Arlington High School Building Committee Finance Subcommittee Meeting Tuesday, August 15, 2023 Conducted by Remote Participation 4:00 PM – 4:30 PM Agenda

8/15/2023 AHSBC Finance Subcommittee Meeting Meeting Materials

Client: Project Name: Project Name: Project No. Report Date:
Town of Arlington Arlington Arlington, MA Arlington High School 1317826 8/8/2023

Arlington High School869 Massachusetts Ave, Arlington, MA
Revisions to Interior Elevation 6/A12.8.1

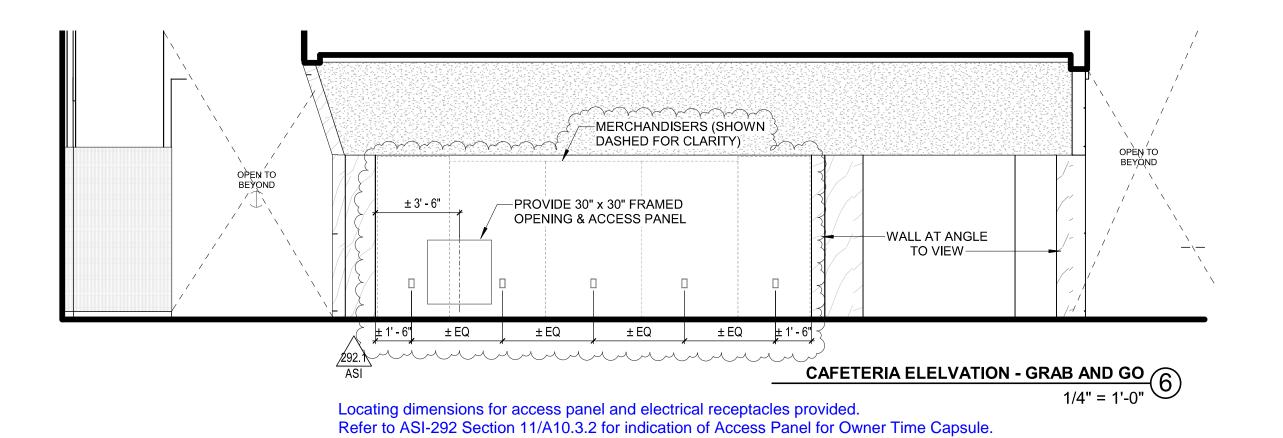
Revision to recessed alcove dimensions and alcove ceiling height at the underside of Forum. A2.0b, A3.0b and detail 8/A8.4.1

reference: Drawings: C3.0.2, C4.0.2A, L-3.1

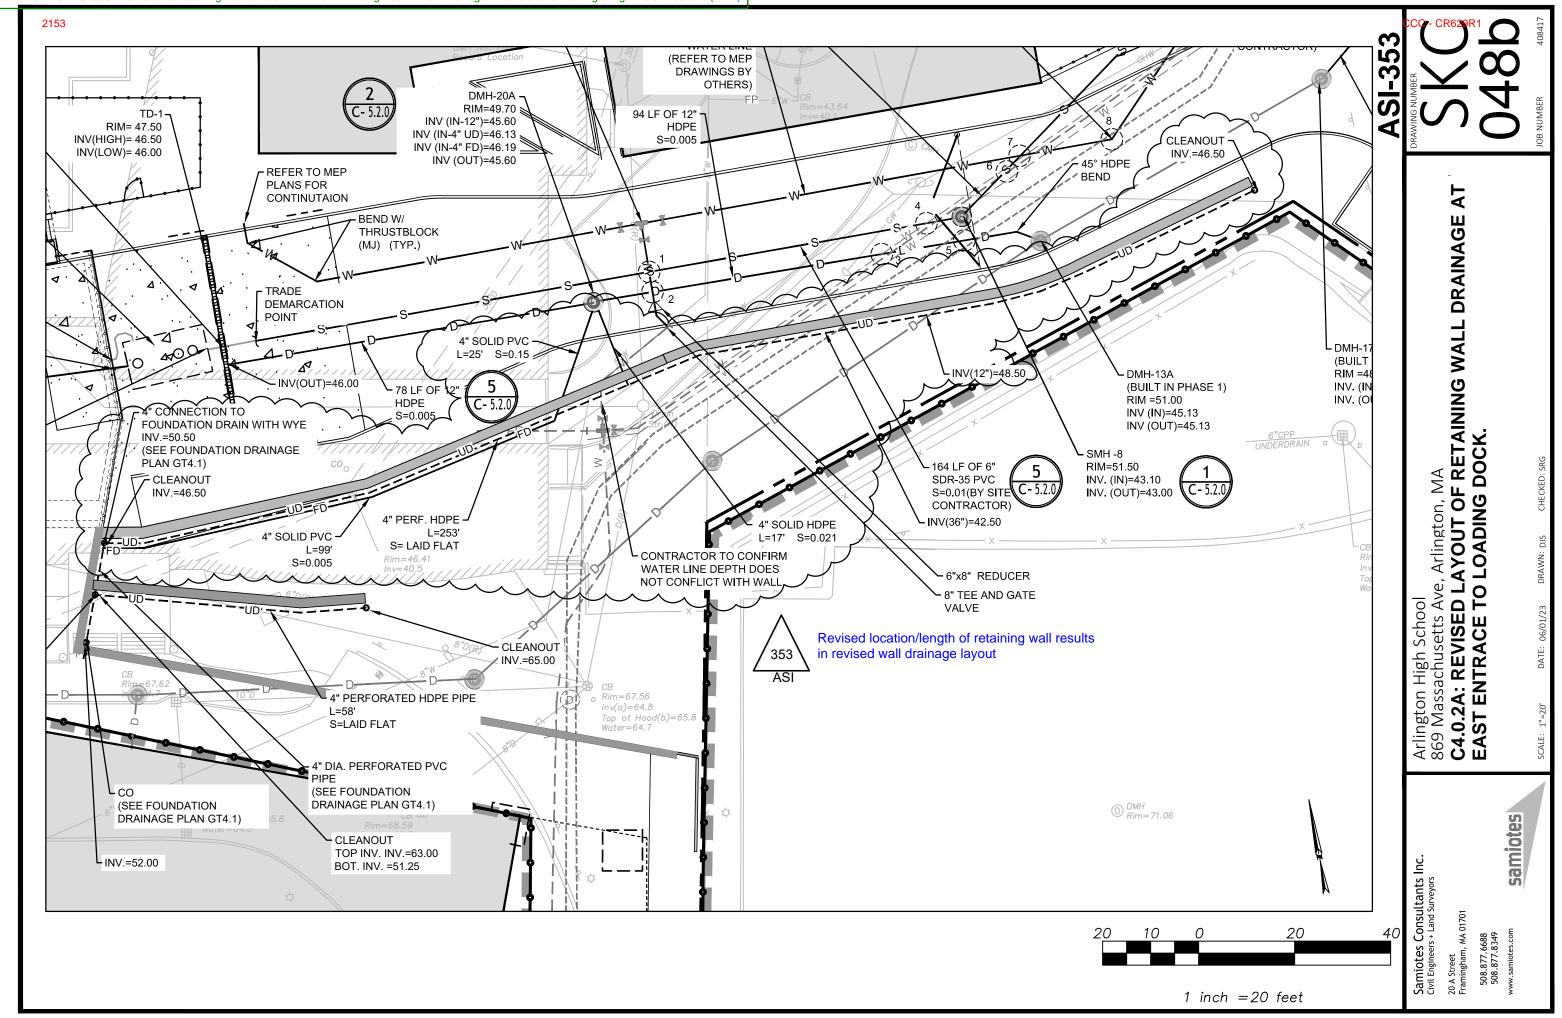
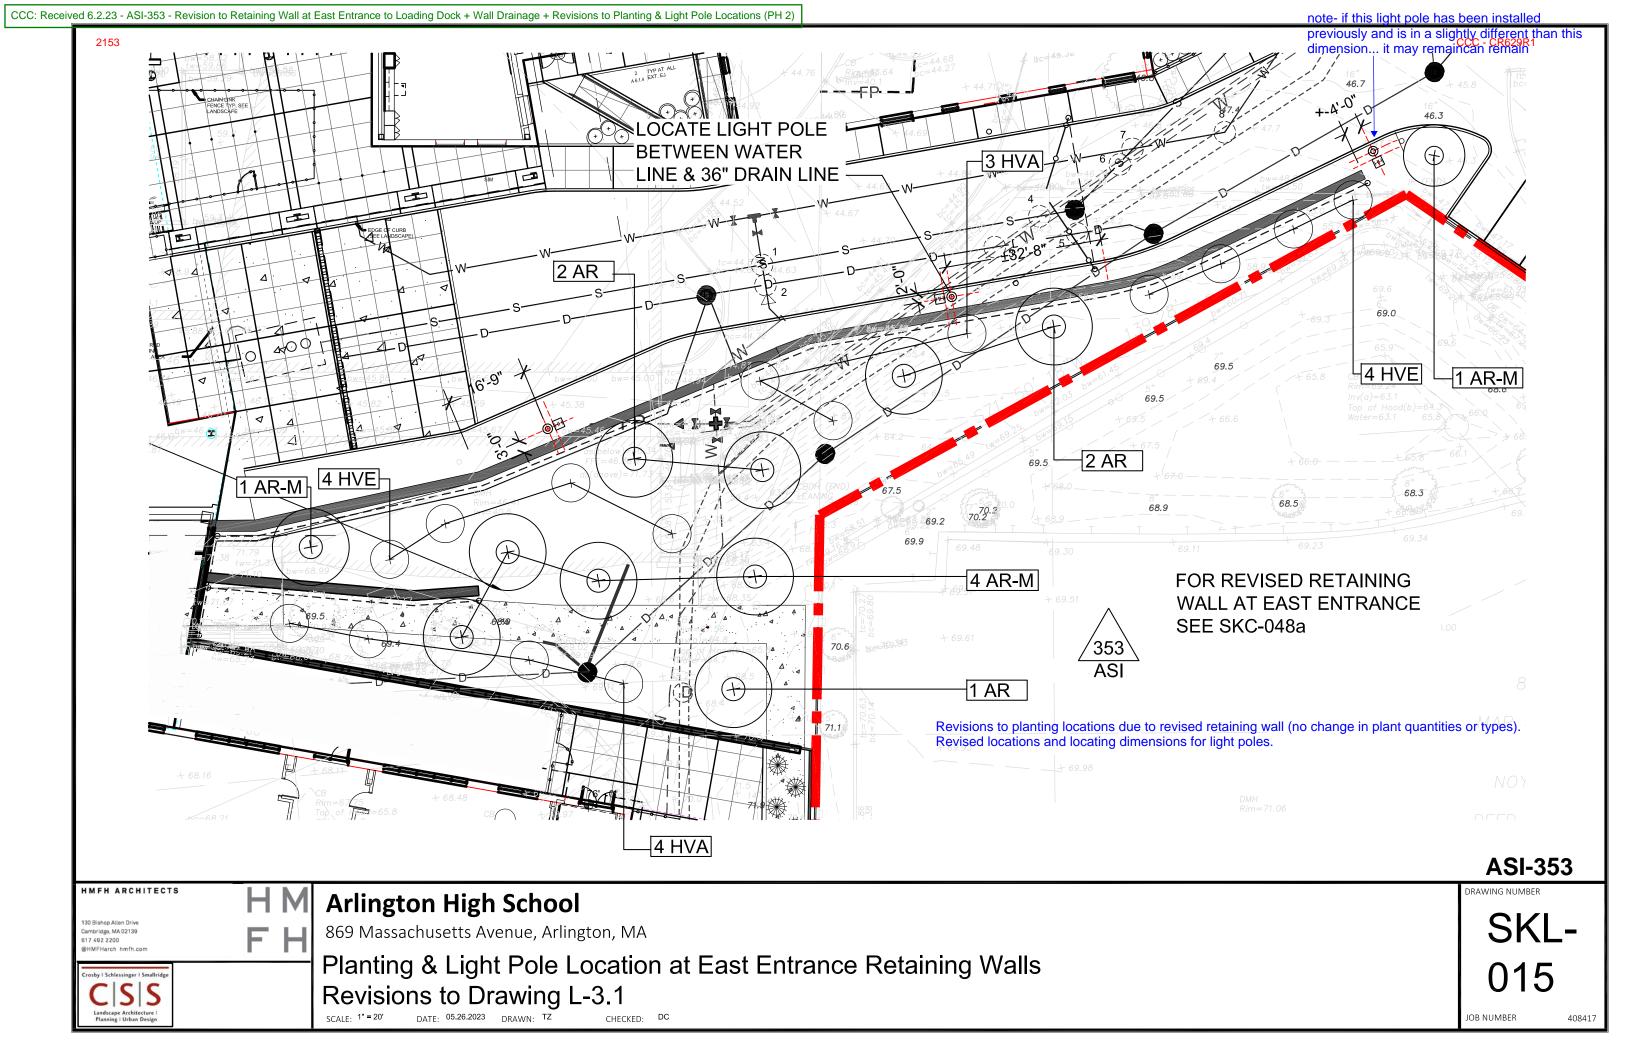
Revision to block retaining wall along (location, height and length) loading dock drive. These revisions made for the following reasons:

Shifted south to provide a wider access area during construction to improve logistics and phasing considerations. Also allows for an improved grading condition on the south side of the wall to better minimize slopes exceeding 3:1 slope and thus allows an improved tree planting condition.

Prior total square footage of wall per prior revisions- 1,623 sf Revised square footage per new drawing- 2,643 sf

Playground Communication Board

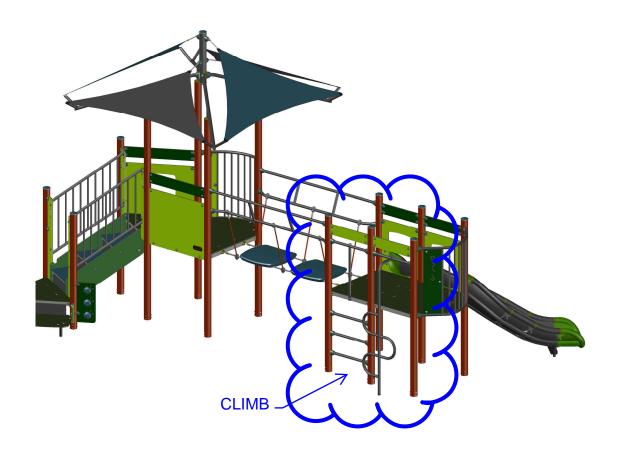
| | | | | | Of Will IIII THE COLON TO | 3 | | | | | | | | |
|-------|------------|--|------------|------------|---------------------------|-------------|-----------|-----------|-----------------|---------------|---------------|------------------|----------|-------------------------------------|
| 638 | | ASI-363 - Play Area Communication Board (Cut Sheet of Selected options) | 6/23/2023 | 7/11/2023 | Submitted | Open | \$2,997 | | | | | 30 | | |

RFI-804

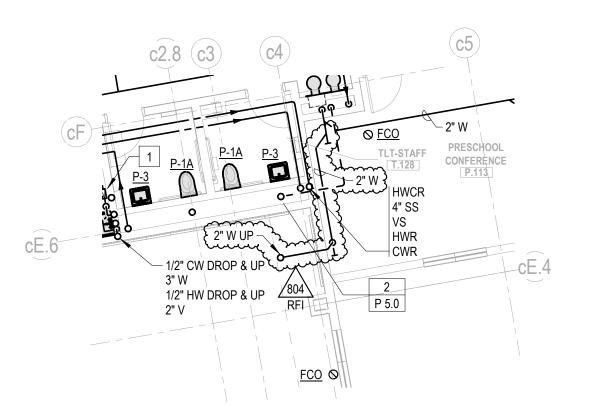
Plumbing Drawing P2.0C shows a P-9 fixture in Preschool OT P.212 of Building C Upper Level 1. After reviewing the drawing it appears there are no plumbing connections (waste, vent, and water) for the fixture. Please provide an updated Plumbing Drawing for the intended design.

See attached sketch SKP-38
